# Access Compliance Report

## Public Rights-of-Way

Intersection ID: 19683	Main Street: CONGRESS_ST	Cross Street: CARNEGIE_BV	Location: NE
ADA ID: 9531F1136D65	Ramp Type: PerpDiag	Initial Pass/Fail: Fail	Overall Compliance: No
		Severity Score: 12.5

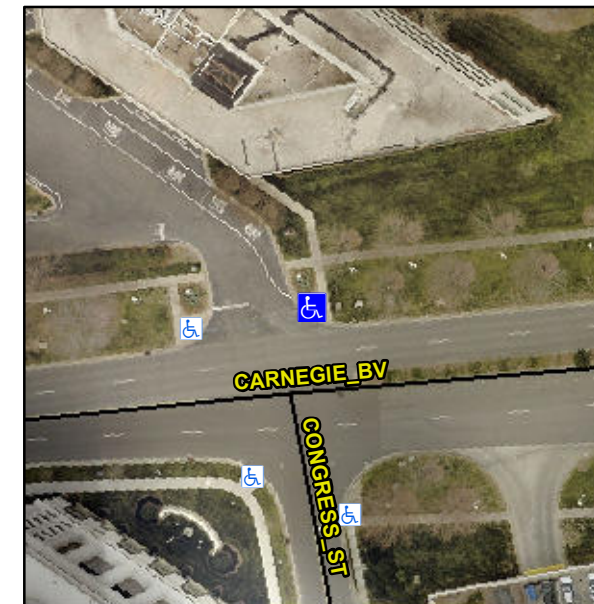
**Not Found, R304.5.3**

Compliance	Description	Data	Compliance	Description	Data
N/A	Ramp Length (in)	72.0	Yes	Ramp Slope (%)	5.1
Yes	Ramp Width (in)	58.0	No	Ramp XSlope (%)	5.5
N/A	Flare Type LT	N/A	N/A	Flare Type RT	N/A
N/A	Flare Slope LT (%)	N/A	N/A	Flare Slope RT (%)	N/A
N/A	Flare Traversable LT?	N/A	N/A	Flare Traversable RT?	N/A
N/A	Landing Length (in)	N/A	N/A	DWS Provided?	N/A
N/A	Landing Width (in)	N/A	N/A	DWS Contrast?	N/A
N/A	Landing Slope (%)	N/A	N/A	DWS Length (in)	N/A
N/A	Landing X Slope (%)	N/A	N/A	DWS Full Width?	N/A
N/A	Landing Curb? (Y/N)	N/A	N/A	DWS Offset (in)	N/A
N/A	Shared Landing?	N/A			
N/A	Gutter Ponding?	N/A	N/A	Gutter Slope (%)	N/A
N/A	Gutter Lip Ht (in)	N/A	N/A	Gutter X Slope (%)	N/A
N/A	Painted X Walk1?	No	N/A	Painted X Walk2?	No
	X Walk 1 Direction	To W		X Walk 2 Direction	To S
N/A	X Walk 1 Width (in)	N/A	N/A	X Walk 2 Width (in)	N/A
	X Walk 1 Slope (%)	2.4		X Walk 2 Slope (%)	6.3
	X Walk 1 X Slope (%)	1.4		X Walk 2 X Slope (%)	1.4

**Remove & Replace Curb Ramp With Two New Directional Ramps or Equivalent.**
